Access Compliance Report

Public Rights-of-Way

(Pedestrian Signals)

Intersection ID: N/A	Main Street:	Cross Street: N/A	Location: N/A
ADA ID: 1C07C2BBC5EF	Signal Type: One Push Button-APS	Overall Compliance: No	Severity Score: BTN 1: N/A BTN 2: N/A No BTN: N/A
Codes/Mitigation Info/Possible Solution		Field Measurements/Component Compliance

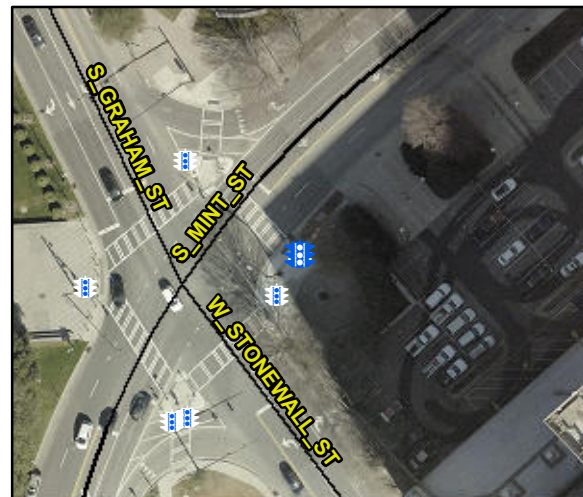
Surveyor Notes: TEXT HT 1/4, DIST BETWEEN ADDL BUTTON 388.0

PROW/ADA: R410.6, TMUTCD 4e.08, R406.2, R209.1, MUTCD 4e.10

Possible Solutions: Replace Signal Push Button With APS Button on New Post. Remove & Replace Sign.
